Access Compliance Report Public Rights-of-Way (Curb Ramps)

Main Street: N/A Cross Street: N_DAISSY_ST Location: NW

ADA ID: RPRK211202114958 Ramp Type: Type 4 - Parallel Initial Pass/Fail: Fail Overall Compliance: No Severity Score: 16

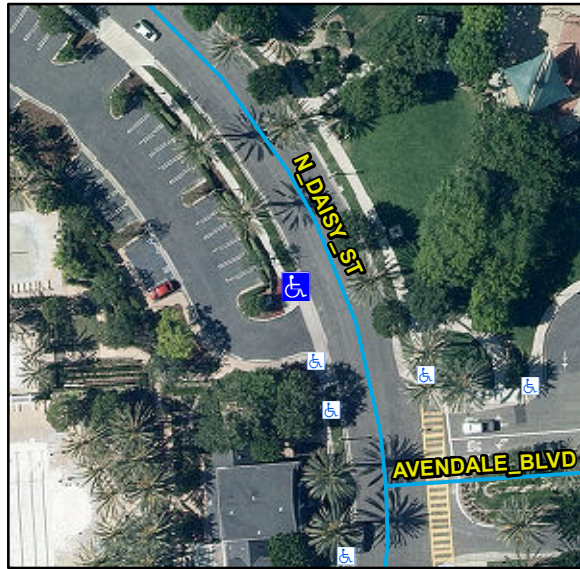
R204.3, R304.3.2, R304.5.3, STD 1115

Compliance	Description	Data	Compliance	Description	Data
N/A	Ramp Length LT (in)	117	N/A	Ramp Length RT (in)	114
Yes	Ramp Width LT (in)	87	Yes	Ramp Width RT (in)	88
No	Ramp Run Slope LT (%)	9.4	Yes	Ramp Run Slope RT (%)	4.4
Yes	Ramp Cross Slope LT (%)	1.3	No	Ramp Cross Slope RT (%)	3.1
N/A	Landing Present	N/A	N/A	DWS Provided	N/A
N/A	Landing Length (in)	N/A	N/A	DWS Contrast	N/A
N/A	Landing Width (in)	N/A	N/A	DWS Length (in)	N/A
N/A	Landing Run Slope (%)	N/A	N/A	DWS Full Width	N/A
N/A	Landing Cross Slope (%)	N/A		DWS Offset Type	N/A
N/A	Landing Movement Obstructed?	N/A	N/A	DWS Offset Left (in)	N/A
	Landing Movement Type	N/A	N/A	DWS Offset Right (in)	N/A
N/A	Landing Shared	N/A			
N/A	Clear Space	Yes			
N/A	Clear Space To Crosswalk (in)	N/A			
N/A	Marked Crosswalk 1	No	N/A	Marked Crosswalk 2	No
	Crossing 1 Direction	S		Crossing 2 Direction	E
	Marked Crosswalk 1 Width (in)	N/A		Marked Crosswalk 2 Width (in)	N/A

Remove & Replace Curb Ramp With Two New Directional Ramps or Equivalent.
